Derwenthorpe S278, Phase 1 Alternative Proposals

S278/11011885/03

ANNEX C

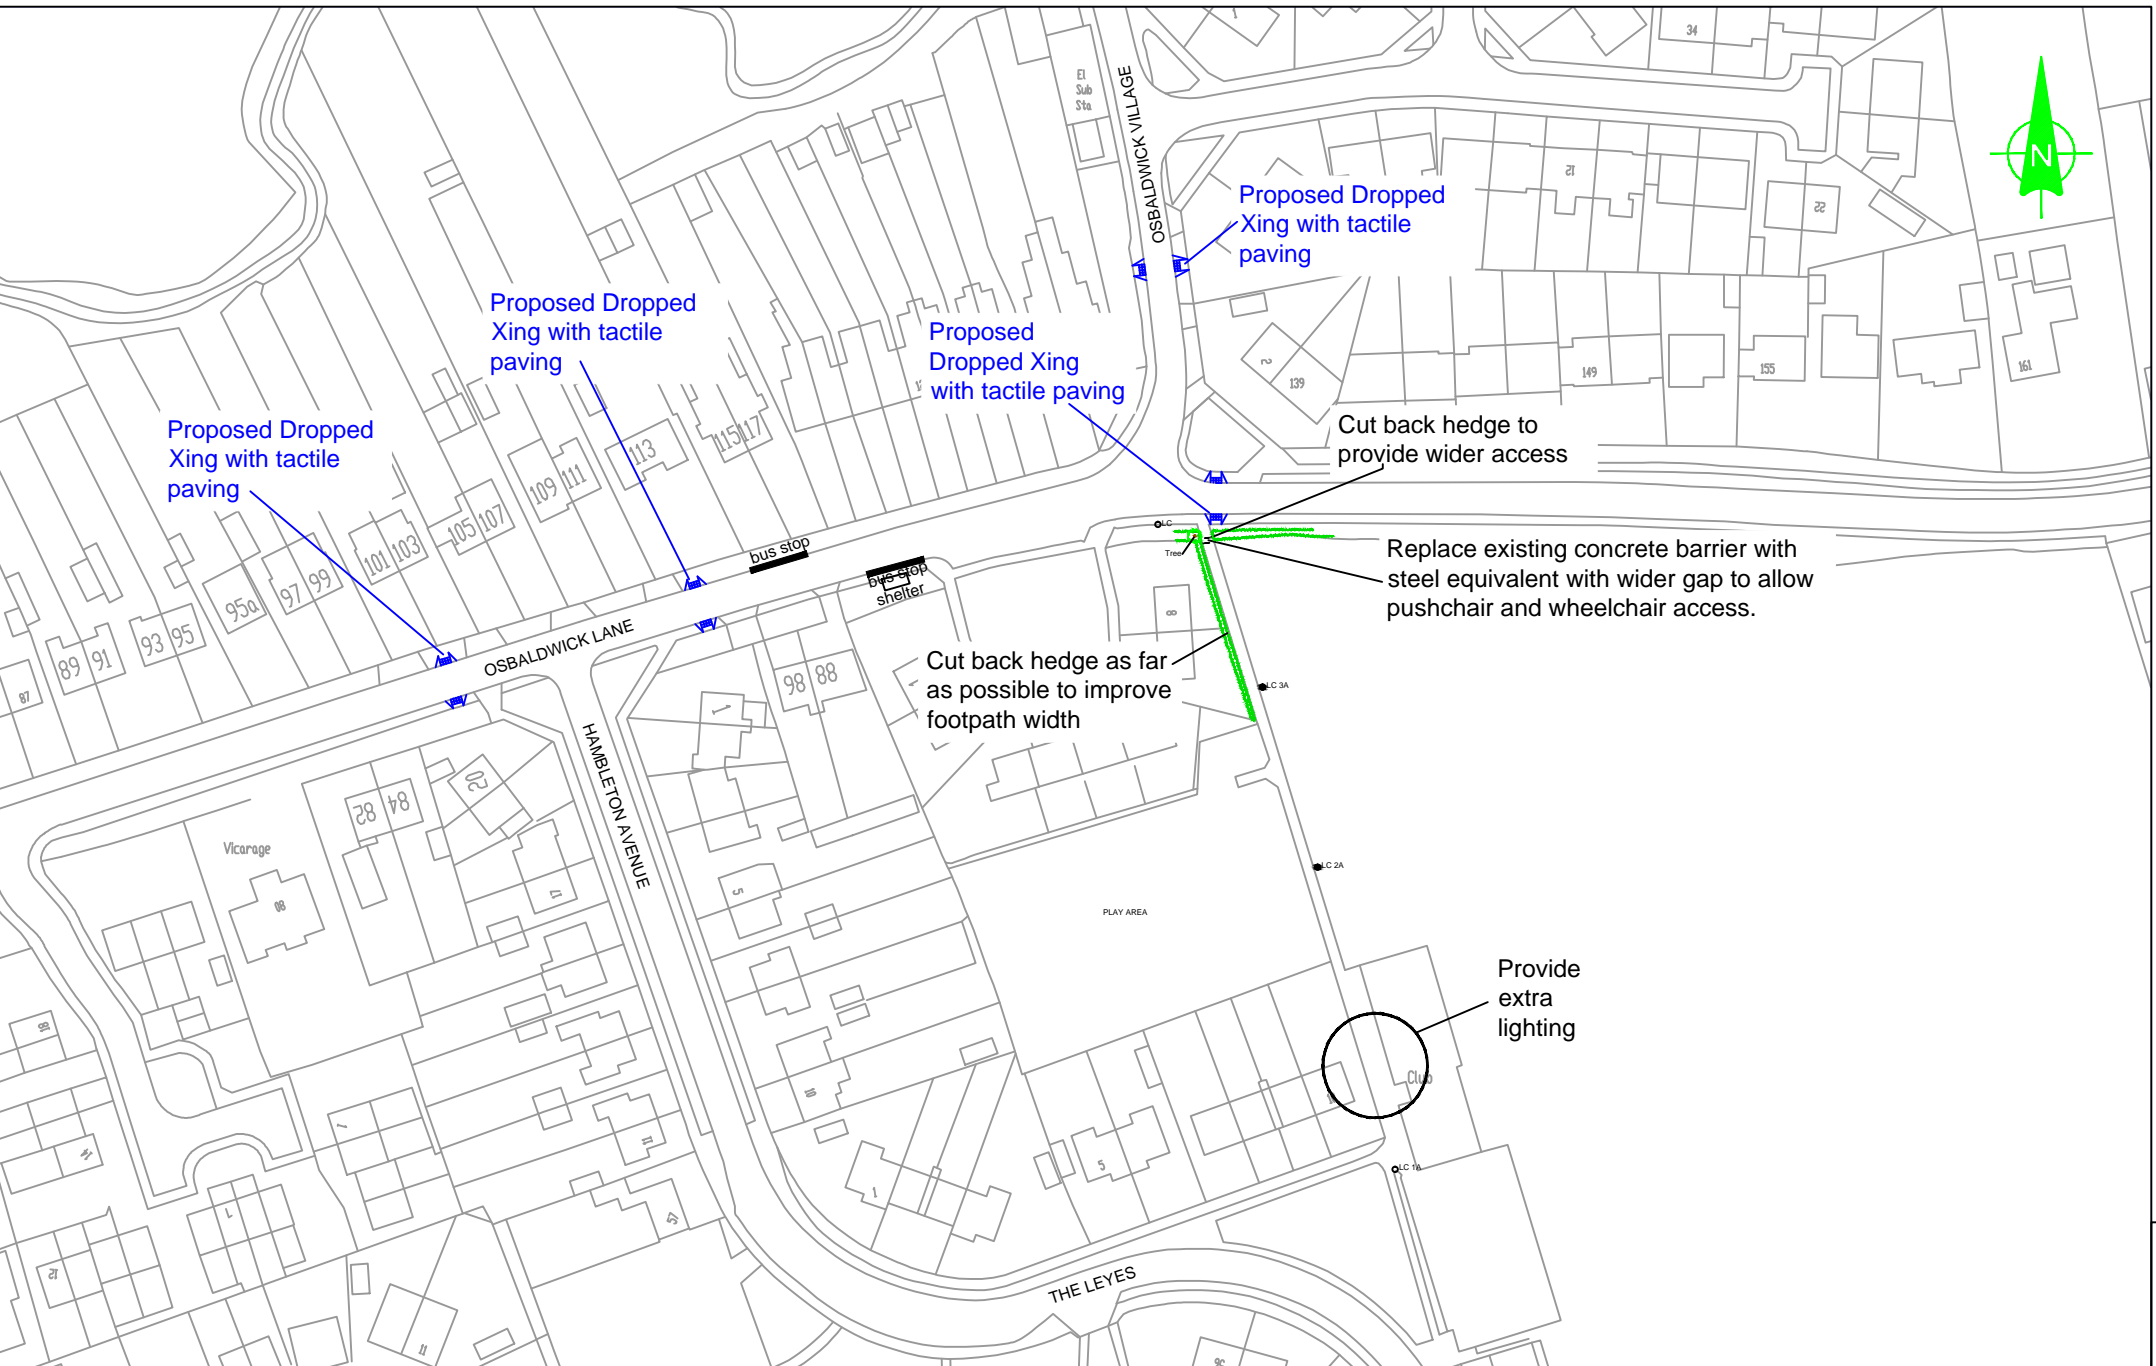
Proposed Dropped Xing with tactile paving

Proposed Dropped Xing with tactile paving

Proposed Dropped Xing with tactile paving

Proposed Dropped Xing with tactile paving

Cut back hedge to provide wider access

Replace existing concrete barrier with steel equivalent with wider gap to allow pushchair and wheelchair access.

Cut back hedge as far as possible to improve footpath width

Provide extra lighting
